HERD Mechanical
Meeting
July 8th, 2021

Open points & Update

Mechanical team
Perugia
L. Mussolin, G. Morettini, E. Mancini

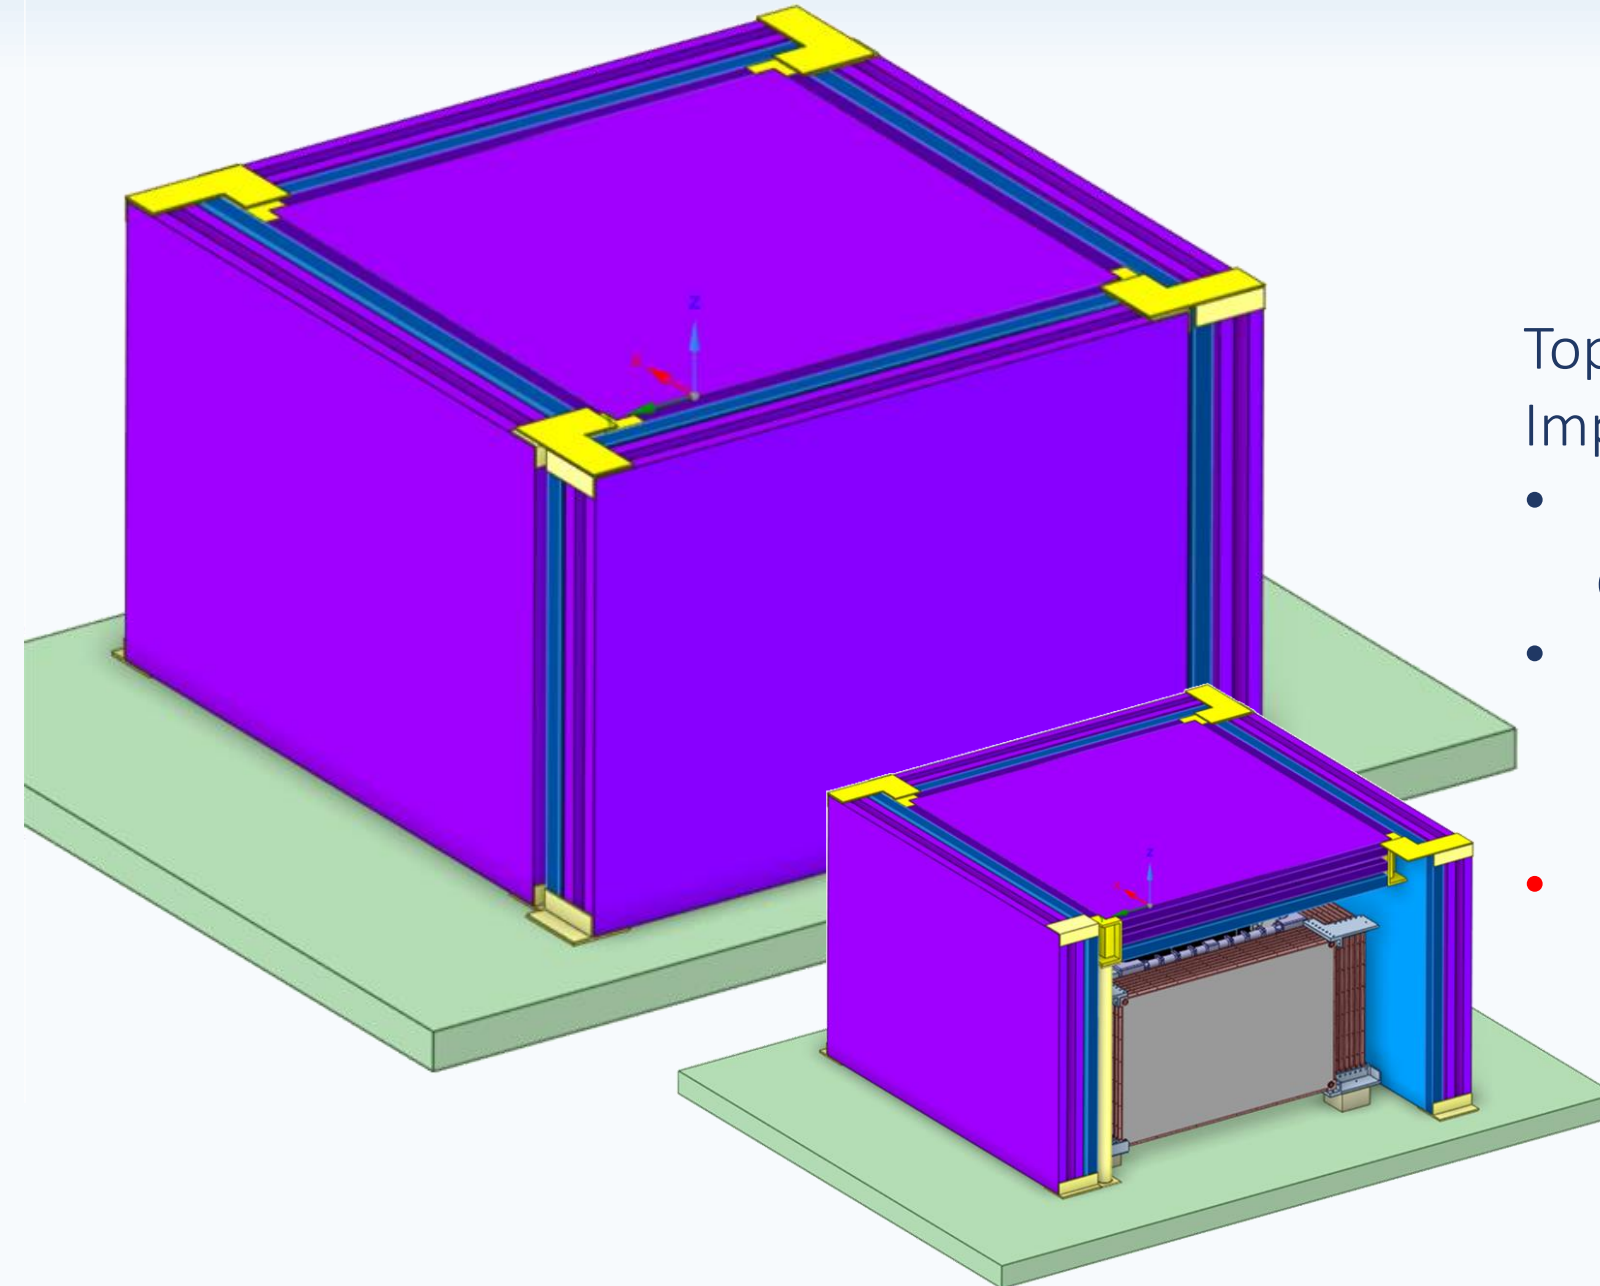
- FIT moved with respect to the previous meeting.
- The bottom clearance is 79mm (smaller than 150mm required by the FIT team for the electronics)
- **Is it possible to pursue this solution? Can the FIT electronics be stacked in the base plate? – IHEP team**
- **Is this fine with the FIT team – FIT team**

Top cover inside the lateral sides

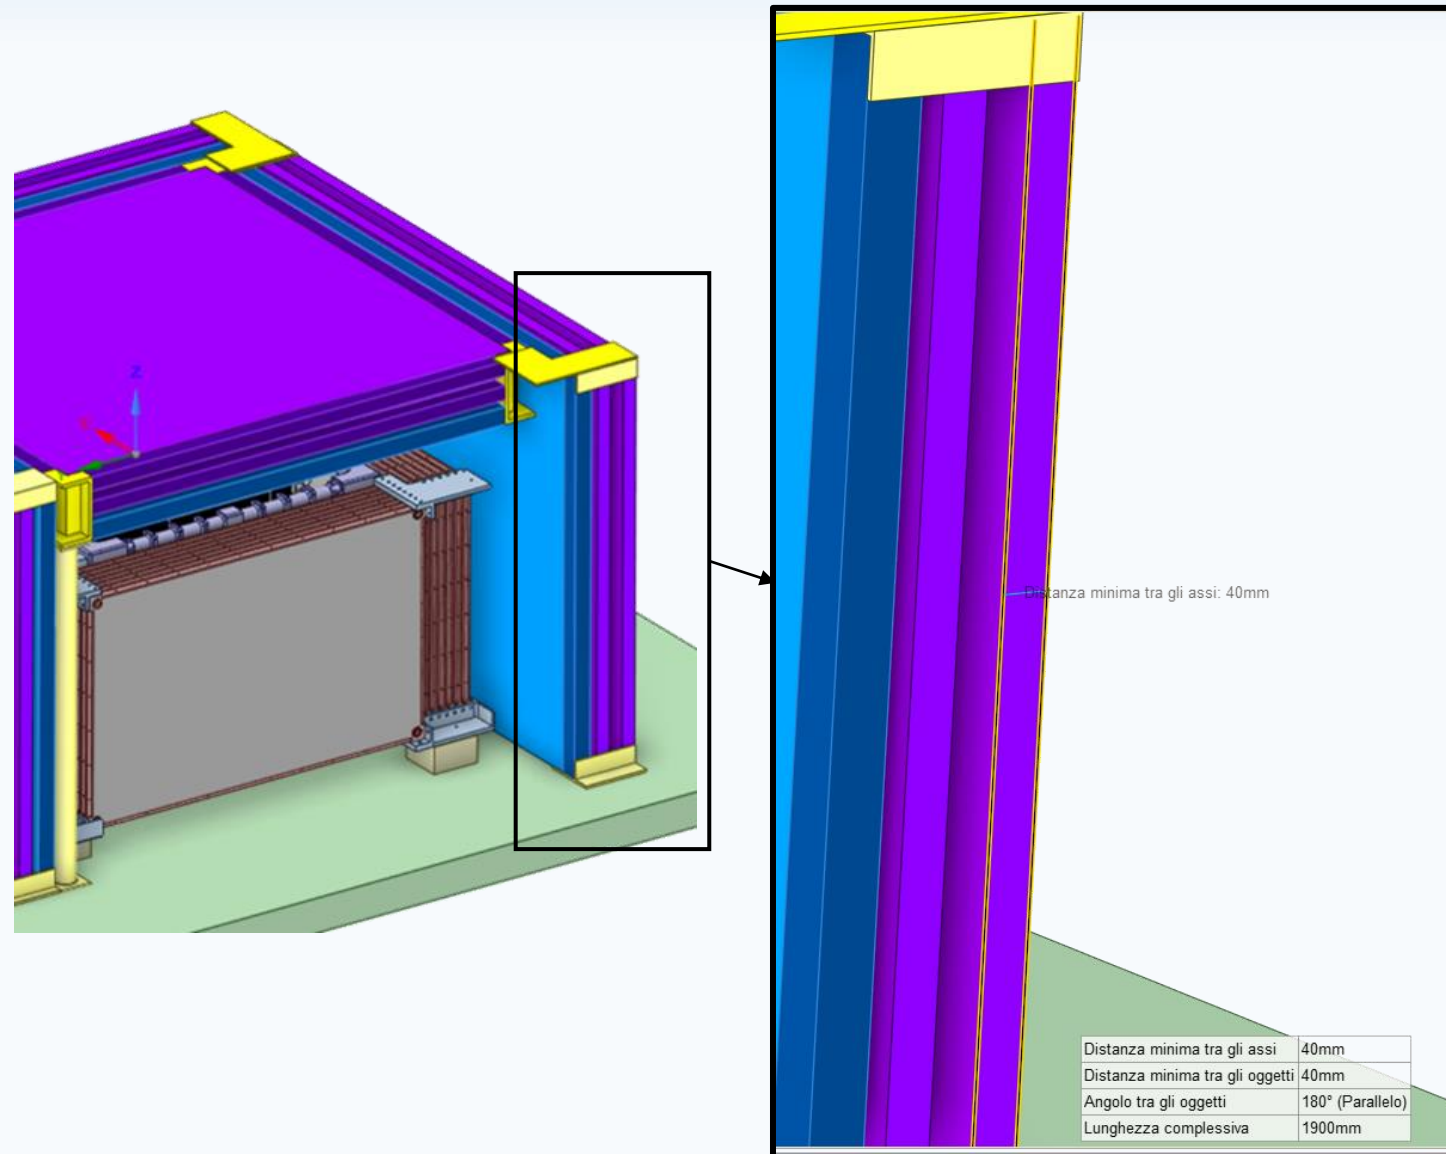
- Nothing changes for the internal detectors
- PSD and SCD top structure has reduced dimensions (closer to the lateral ones)
- **Impact on hermeticity TBD**
